UNITED STATES ENVIRONMENTAL PROTECTION AGENCY

Re: Comments on the Sherwin-Williams August 16, 2004, Remedial Investigation Work Plan Implementation Sequence (Implementation Strategy); Gibbsboro, NJ

## **Comments on the August, 2004 Remedial Investigation Work Plan Implementation Sequence (Implementation Strategy)**

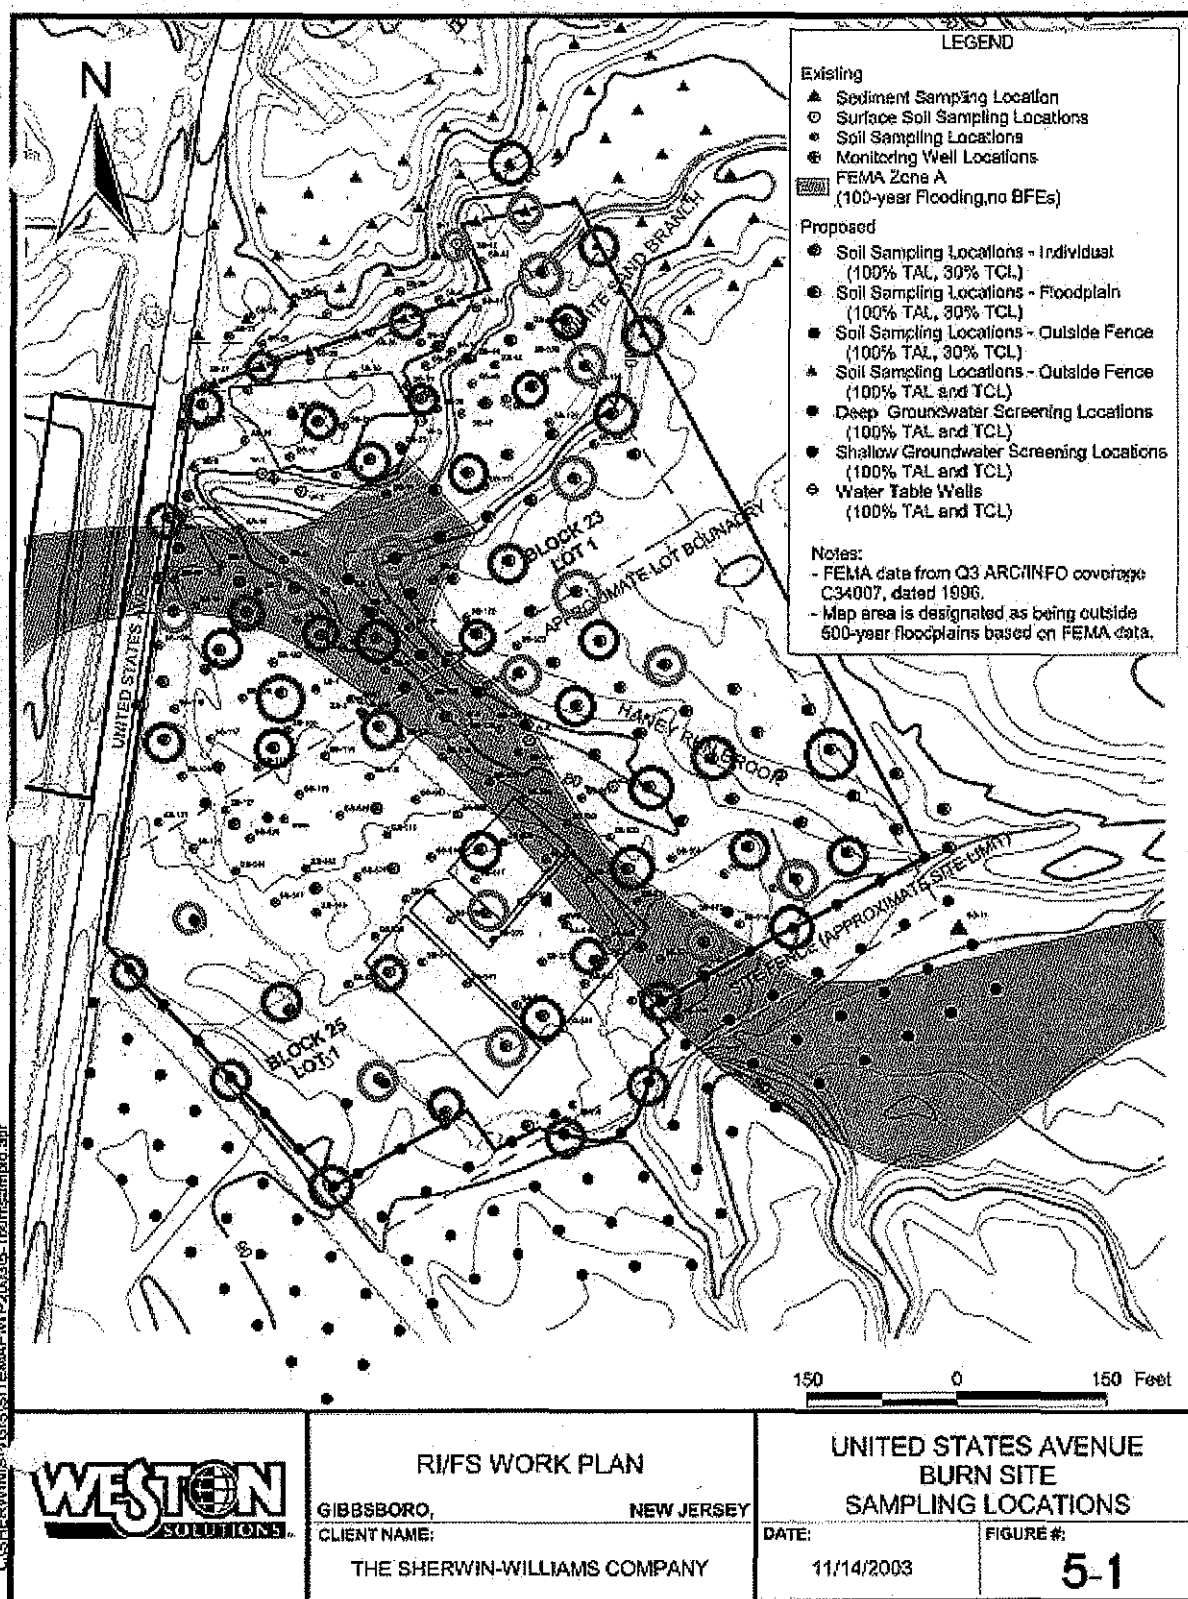
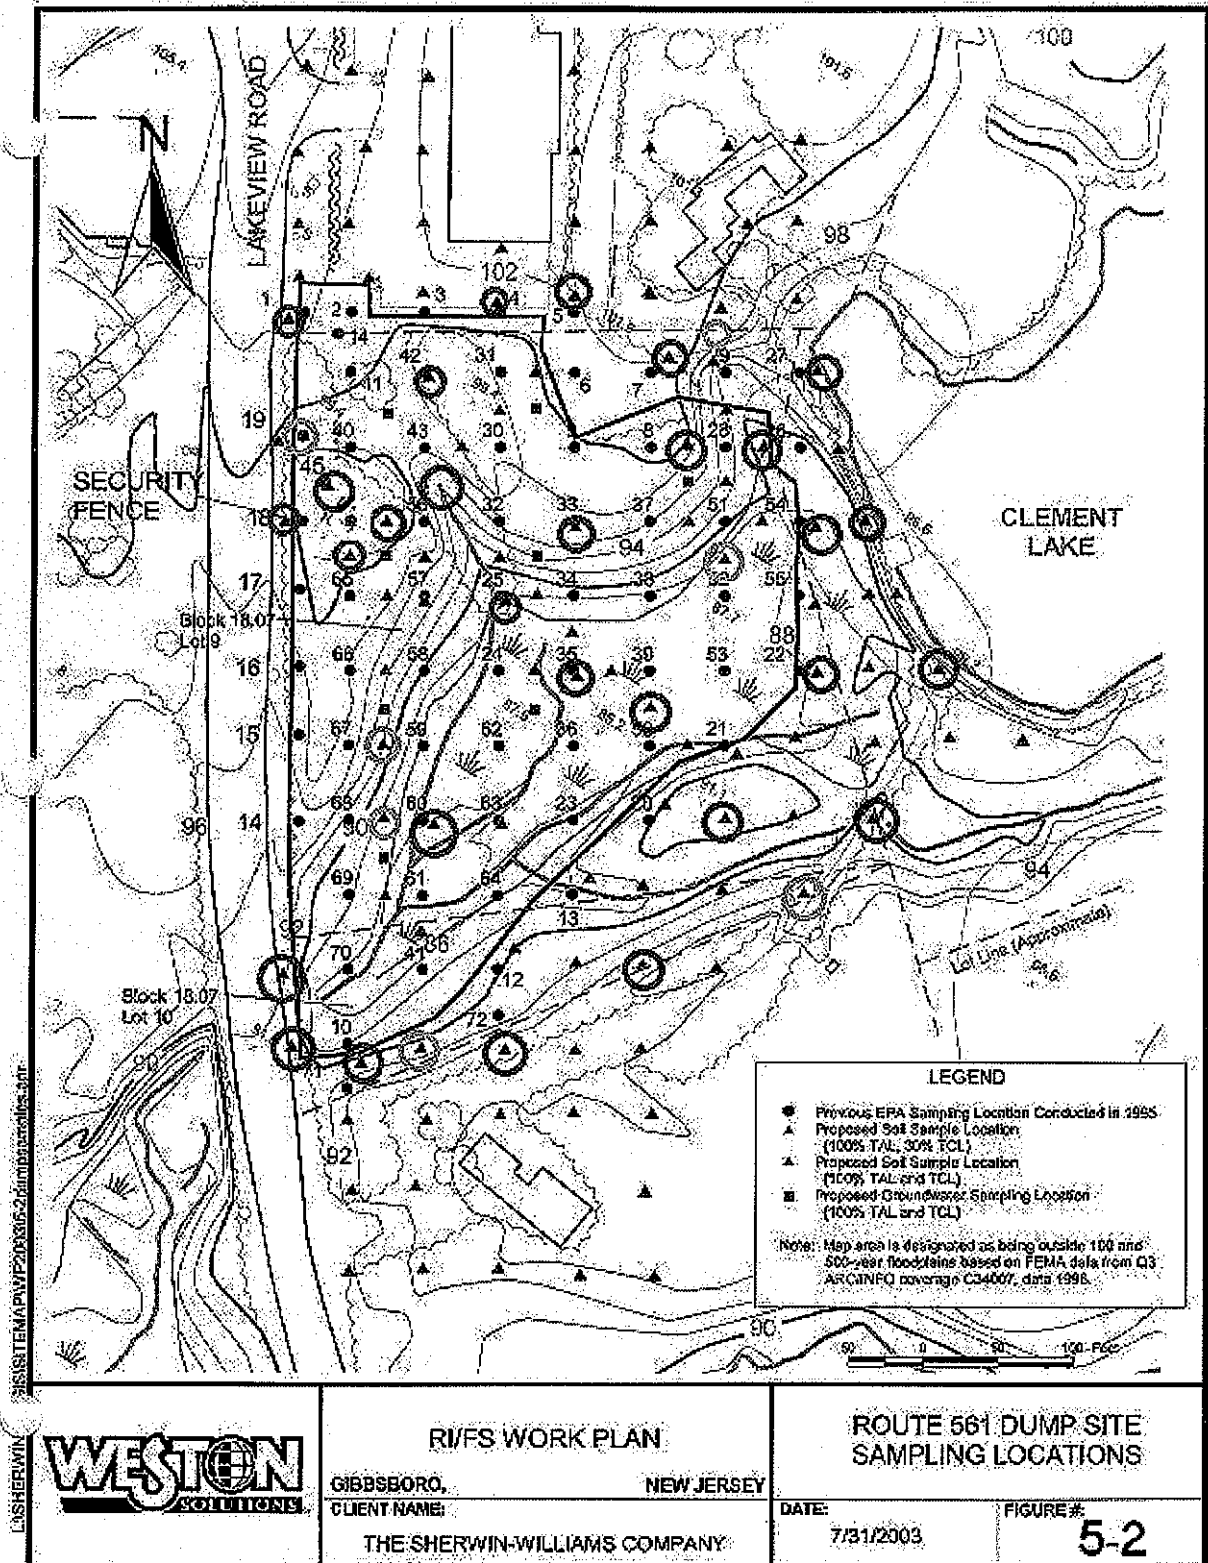
EPA has used the following color scheme for figures 5-1, 5-2, and 5-9 to translate our comments on the strategic sampling locations submitted by Sherwin-Williams:

Red = sample locations agreed upon by both EPA and Sherwin-Williams

Blue = sample locations recommended by EPA

Green = sample locations recommended by Sherwin-Williams

Note: only at the Railroad Site has EPA recommended an increase in the total number of samples previously suggested by Sherwin-Williams. The initial total suggested by Sherwin-Williams was 14, EPA is proposing 17.

R/FS WORK PLAN		ROUTE 561 DUMP SITE SAMPLING LOCATIONS	
	GIBBSBORO, CLIENT NAME:		NEW JERSEY	
	THE SHERWIN-WILLIAMS COMPANY		DATE: 7/31/2003	FIGURE #: 5-2

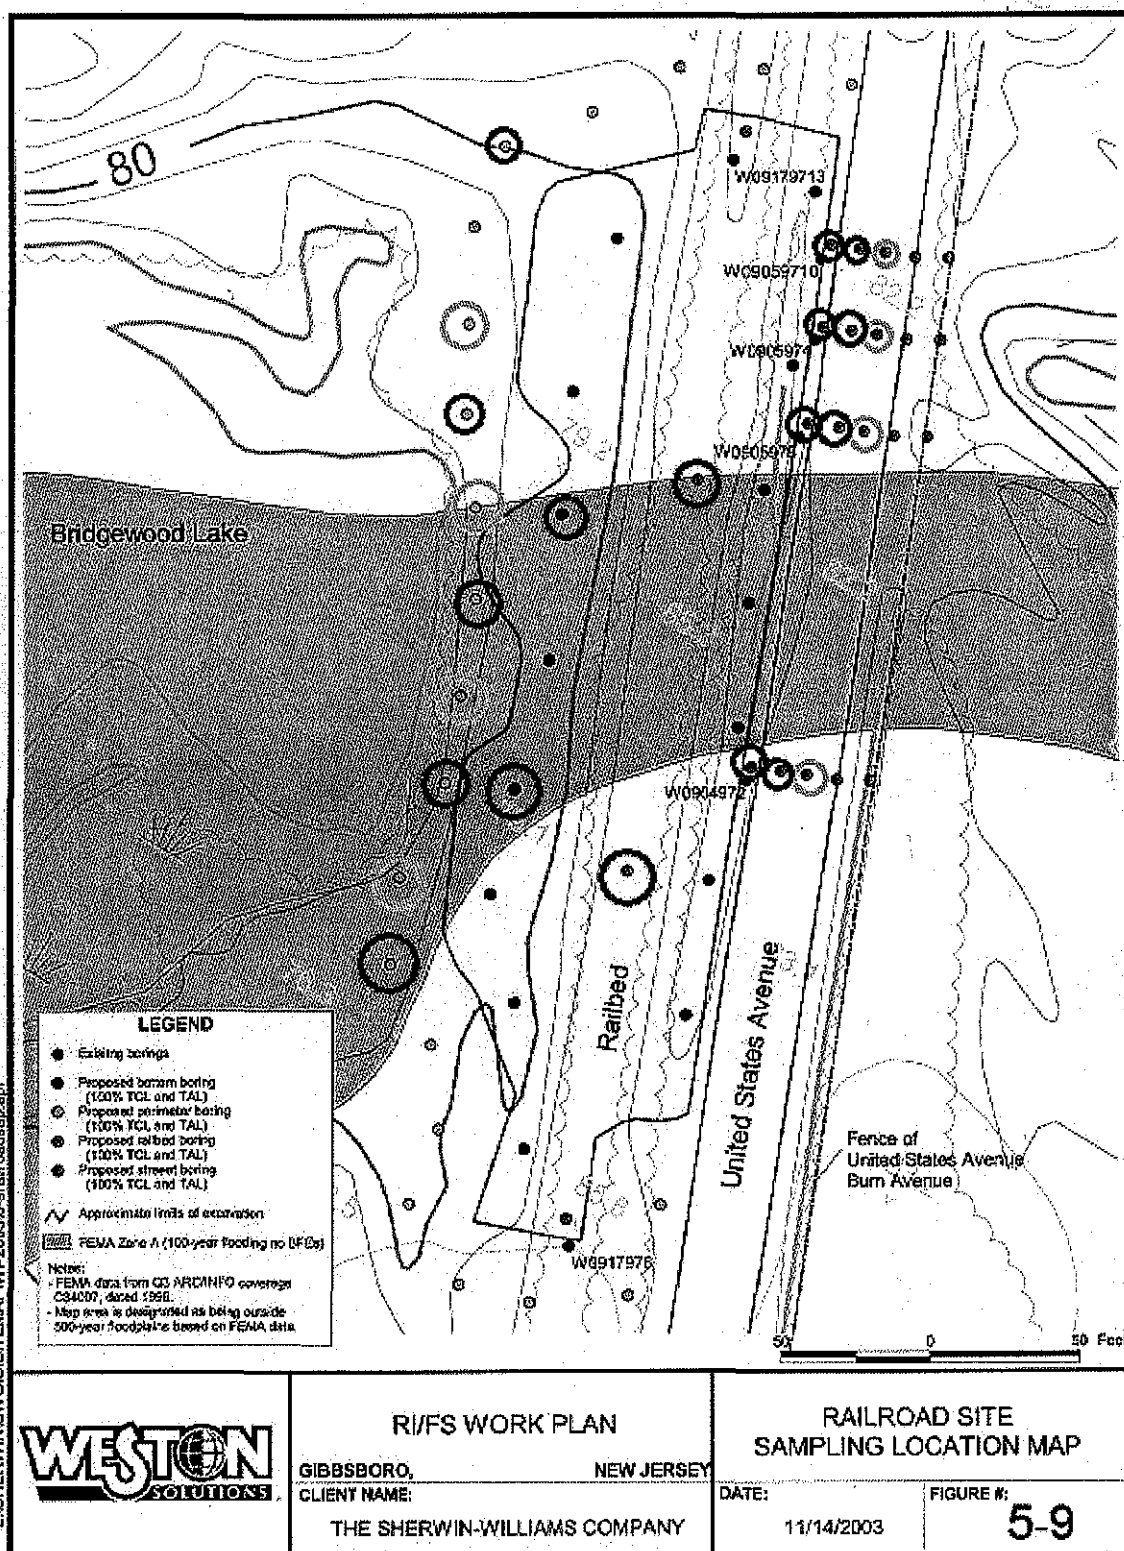
- b. The following figures, which depict areas as well as sampling locations selected by Sherwin-Williams, are approved by EPA as submitted with the Implementation Strategy: Haney Run Brook (Figure 5-3); White Sands Branch (Figure 5-4); Bridgewood Lake (Figure 5-5); and Vacant Lot (Figure 5-8).
- c. The following figures: United States Avenue Burn Site (Figure 5-1); Route 561 Dump Site (Figure 5-2); and the Railroad Site (Figure 5-9) have been submitted with sample locations recommended by the EPA. Note, due to the fact that EPA did not have an electronic copy of Sherwin-Williams Implementation Strategy, we used maps which were taken from the approved RI/FS Workplan. As a result, sample locations previously recommended by Sherwin-Williams are not depicted in manner in which they were on the Implementation Strategy figures.
